## RESPONSE TO REQUEST FOR ADDITIONAL INFORMATION

### APR1400 Design Certification

Docket No. 52-046

RAI No.: 43-7887

**APR1400 DCD TIER 2**7.1.2.21 Conformance with GDC 19

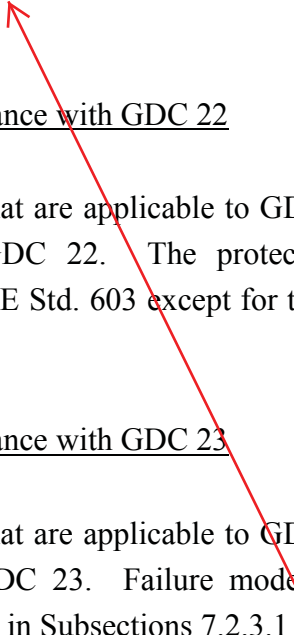
#### **Question No. 07.01-14**

Section 7.1.2.23 of DCD Tier 2 will be revised as follows:

To be revised as follows: The applicable I&C systems listed in Table 7.1-1 are designed to meet the requirement of GDC 21 (Reference 21). Clause 5.1 of IEEE Std. 603 corresponds to the requirement that no single failure results in loss of the protection function as stated in GDC 21. The protection system is designed to conform to Clause 5.1 of IEEE Std. 603. Conformance to IEEE Std. 603-1991, Clause 5.1 is described in Section A.5.1 of the Safety I&C System Technical Report. The protection system is designed to meet the requirement that removal from service of any component or channel shall not result in loss of the required minimum redundancy; Sections 7.2.1.8 and 7.3.1.7 describe the safety systems' compliance.

Section 7.1.2.23 of DCD Tier 2 will be revised as indicated on the attached mark-up.
